AP1000[®] nuclear power plant design by Westinghouse Electric Company LLC

Final assessment report

**Other environmental
regulations**

Final assessment report – Other environmental regulations

47 The effluent system of the AP1000 is shown in ER Figure 6.2-2:

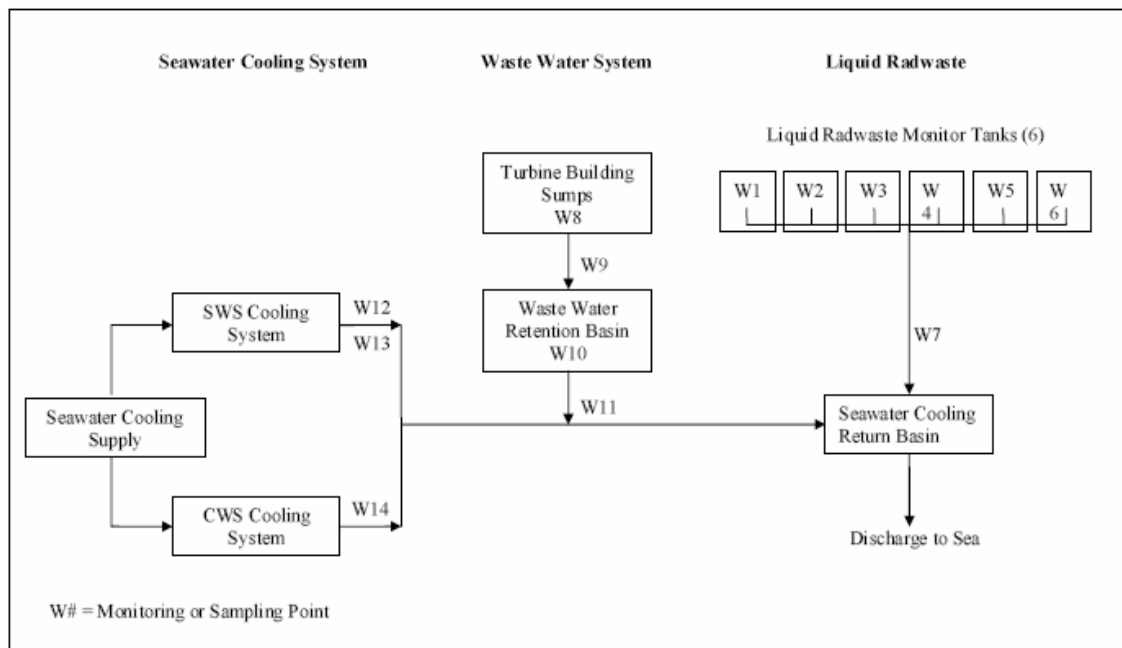
48 We would place controls on four effluent release points in a permit:

- W7 – discharge for liquid radwaste monitor tanks serving the liquid radioactive waste system (WLS);
- W11 – discharge line of the wastewater system (WWS) from the wastewater retention basin;
- W14 – discharge line of the circulating water system (CWS);
- W12 – discharge line of the service water system (SWS).

- effluent from the liquid radwaste system discharged through point W7 (WLS)(ERs3.4.3). The radioactivity of this effluent is dealt with in our report EAGDAR AP1000-05 (Environment Agency 2011b) but the effluent will also contain chemicals and metals, e.g. corrosion products, that will need to be covered in a discharge permit from us and which therefore merit consideration here;
- effluent from the Wastewater system (WWS) that serves the drains in the non-radioactive building areas of the AP1000. The effluent is collected in sumps and then pumped through an oil separator to the wastewater retention basin for settling of suspended solids and treatment, if required. The basin is discharged, after sampling and appropriate discharge approval, to the seawater return sump through point W11, (ERs4.2.1.1 and ER Figure 6.2-2).

Westinghouse state that the design of the wastewater retention basin is a site specific matter and have not provided any detailed information. We have therefore not been able to assess this aspect at GDA. The operator will be required to submit the design details including justification of retention volume to support a site specific permit application.

127 A schematic showing the proposed treatment and disposal of non-radioactive waste is shown in Figure 4.3-1 of the ER:

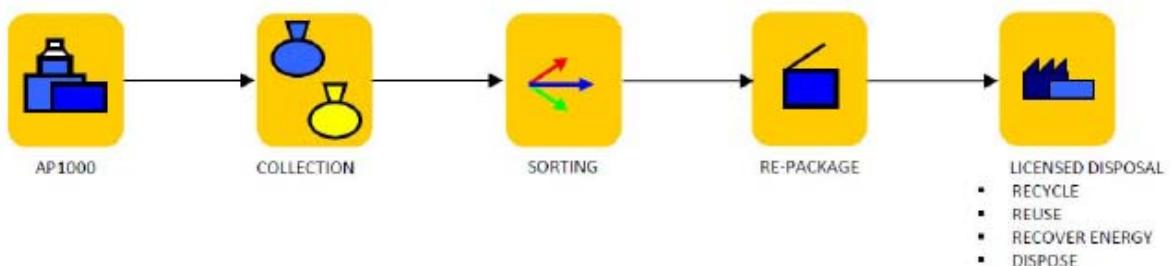
128 The Health Protection Agency (GDA89) provided the following response: '*The Health Protection Agency notes the EA's proposal to include waste from construction activities in the waste strategy for each site at the site-specific permitting stage. However, in order to do this the EA should ensure that construction does not take place before the permitting process has started. If it is not possible to unilaterally impose this then this aspect may instead need to be addressed through planning controls.*'

129 We have considered this response and therefore, we have removed our assessment finding (from our preliminary conclusion in our consultation document) on this matter. We note that under the provisions of the Site Waste Management Plans Regulation 2008 (SWMPR 08), the future operator shall produce a Waste Management Plan for construction projects with an estimated cost greater than £300,000.
